RE: ENERGY STAR® Clothes Dryers Draft 2 Version 1.0 Specification

This letter comprises the comments of the Pacific Gas and Electric Company (PG&E), Southern California Gas Company (SCGC), San Diego Gas and Electric (SDG&E), and Southern California Edison (SCE) in response to the Environmental Protection Agency (EPA) ENERGY STAR® Clothes Dryers Draft 2 Version 1.0 Specification.

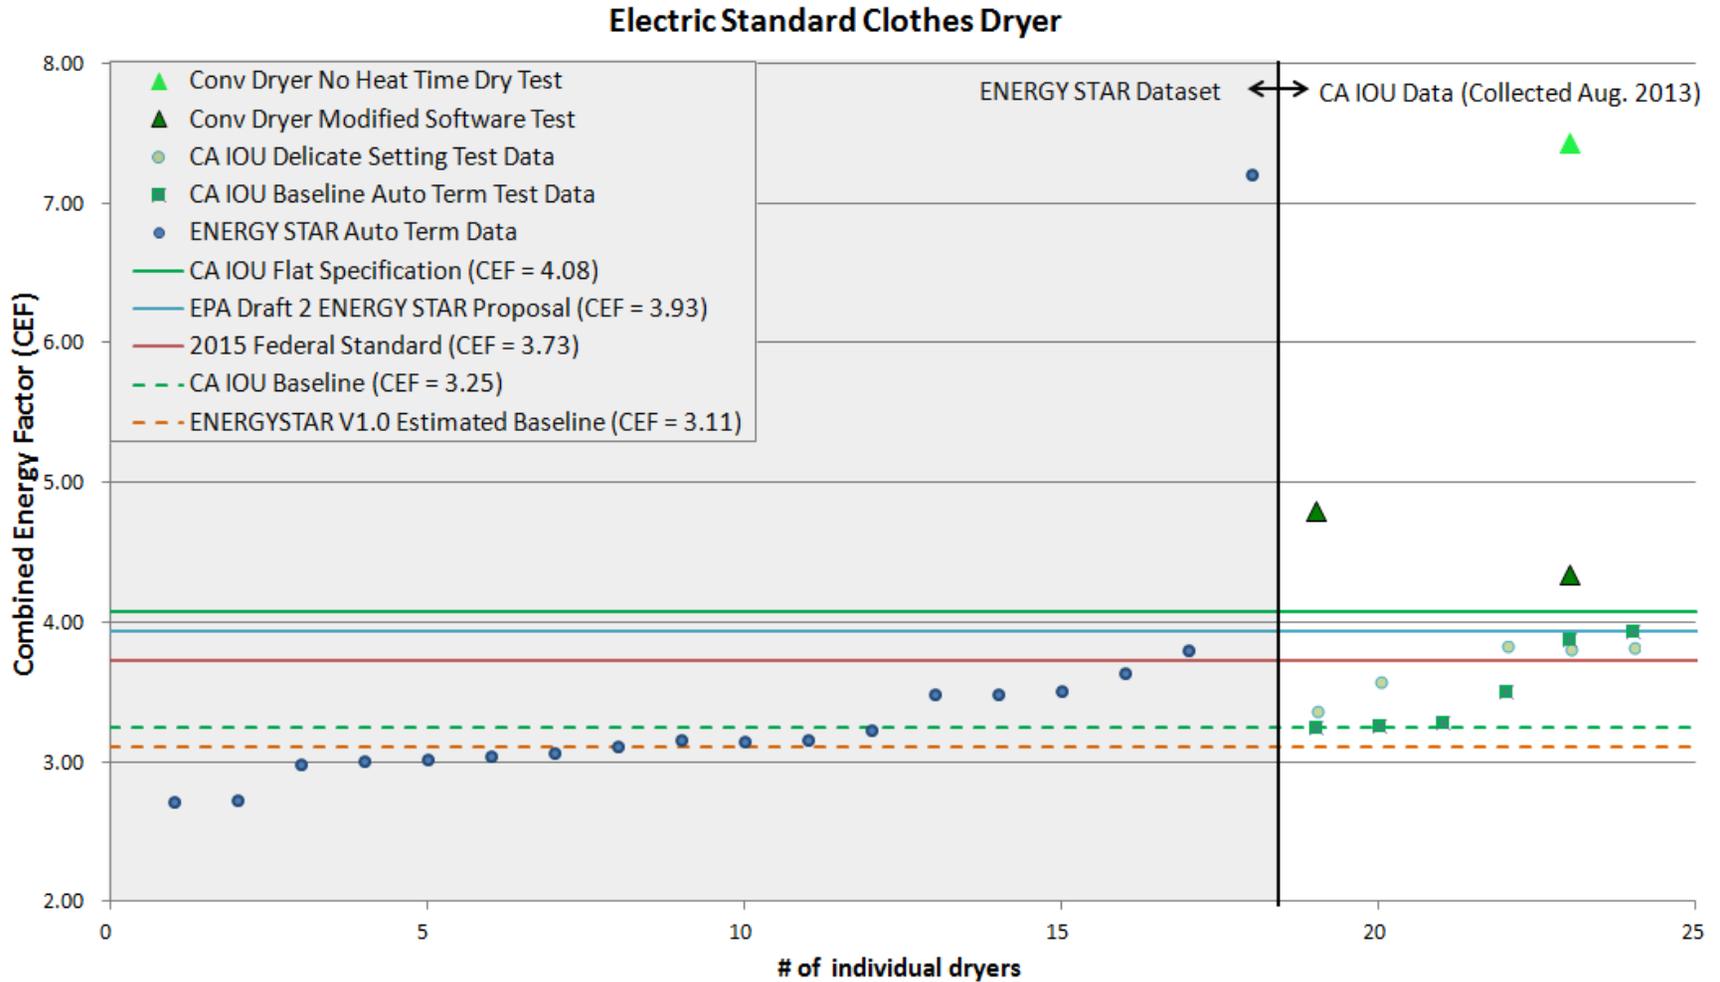
Figure 8 shows additional baseline data from testing conducted by Ecova on behalf of the California IOUs and Northwest Energy Efficiency Alliance (NEEA), indicating that the baseline should be 4% higher.<sup>12</sup> If EPA applied the same 20% energy savings to this higher baseline, the specification CEF would be 4% higher, or CEF = 4.08. This CEF could be used as the specification line independent of drying time, but applying to the fast mode. This would not guarantee that consumers have a slow drying option that would be very high efficiency. However, any slower modes offered would likely be higher efficiency. There would be no drying time limitation on this mode so as to allow technologies such as heat pump dryers. Table 2 shows the option 3 proposal for all product categories.<sup>13</sup>

**Figure A. CA IOU proposed CEF specification line 2014 Emerging Technology Award for all categories of electric dryers.** The green line represents a proposed CA IOU ENERGY STAR specification line that increases efficiency stringency (CEF) with drying time.

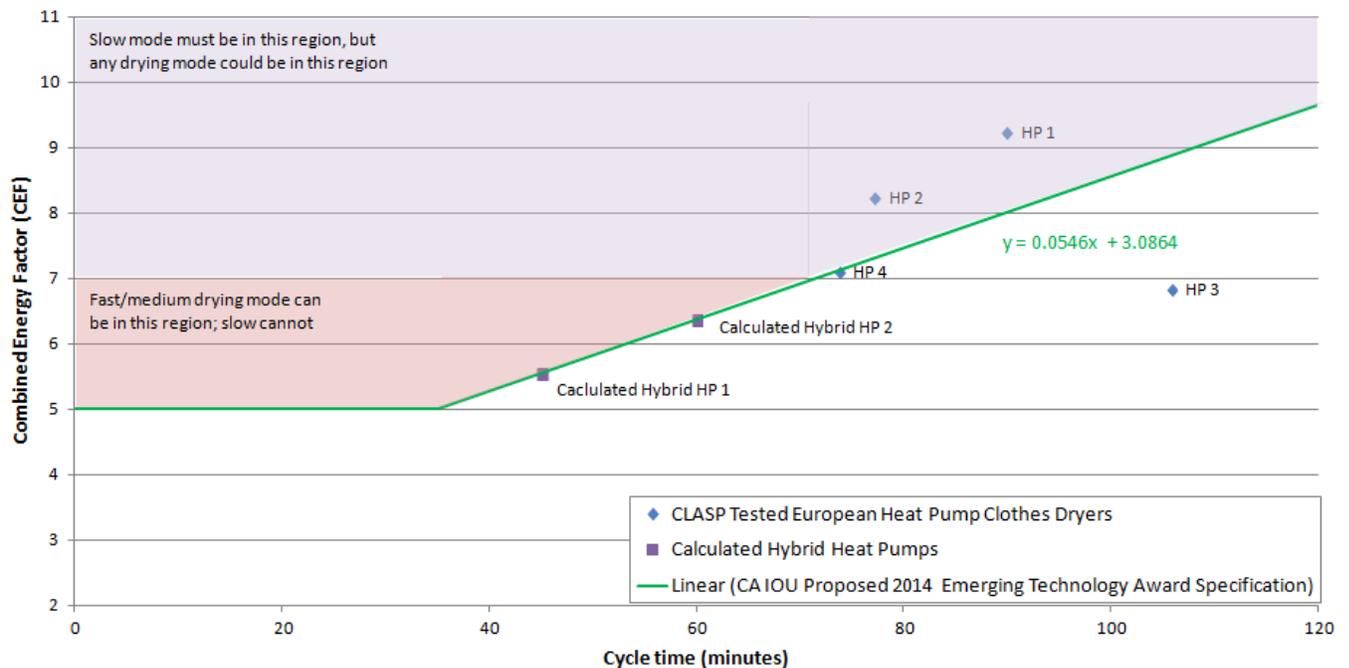
To develop an initial proposal, we used the four heat pump dryer tests performed for The Collaborative Labeling and Appliance Standards Project (CLASP) (see Figure A). We also calculated what CEF a hybrid heat pump might have.<sup>18</sup> Here we roughly use the best-fit line as the proposed specification (see Table A). One may argue that all heat pumps should be able to qualify, but in reality, a vented heat pump would likely be lower cost, greater efficiency, and shorter drying time. Furthermore, these European heat pump dryers' automatic termination systems were not optimized for the DOE test procedure.
